Authorized Field Change

AFC G-07906

Subject: Install EGR Cooler Deaeration Hose Restrictor

Model: 1300, 3200, 4300, 4400, 8500, CE, FE, RC, and RE Bus

Figure 1 EGR Cooler Deaeration Hose Restrictor

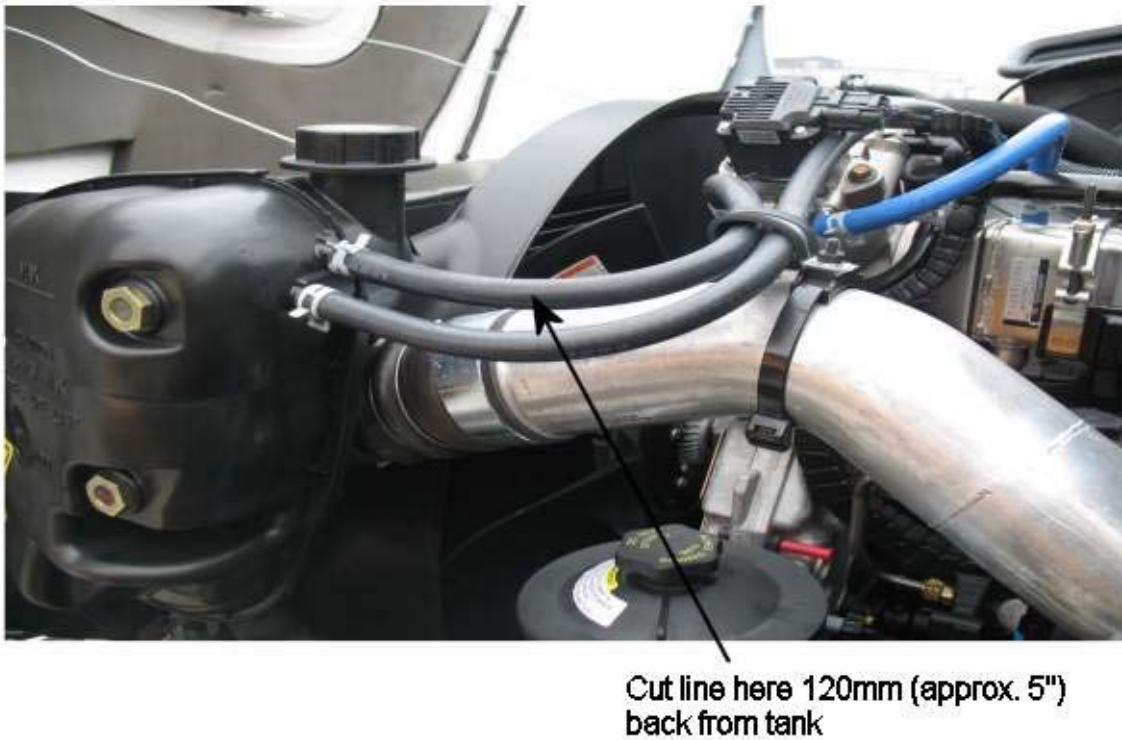
MaxxForce DT engines are experiencing inadvertent low coolant warning light/buzzer activation.

It has been determined by International Truck and Engine Corporation that the above listed models were built with an EGR cooler deaeration hose that the inside diameter is too large and the restrictor fitting needs to be installed.

1. Loosen coolant system pressure cap.
2. Measure back 120 mm (approximately 5") on the top deaeration hose at the surge tank (Figure 1).

3. Cut deaeration hose at the 120 mm (approximately 5") from the surge tank.
4. Install hose clamps from the parts kit on the hose on both sides of the cut.
5. Install restrictor. You will notice that the restrictor has a large hole in one end and a smaller hole in the other end, it makes no difference which way the restrictor is installed.
6. Slide clamps along the hose so they are positioned over the ends of the restrictor.
7. Tighten coolant system pressure cap.
8. Check for leaks and insure that the surge tank is at the full level.
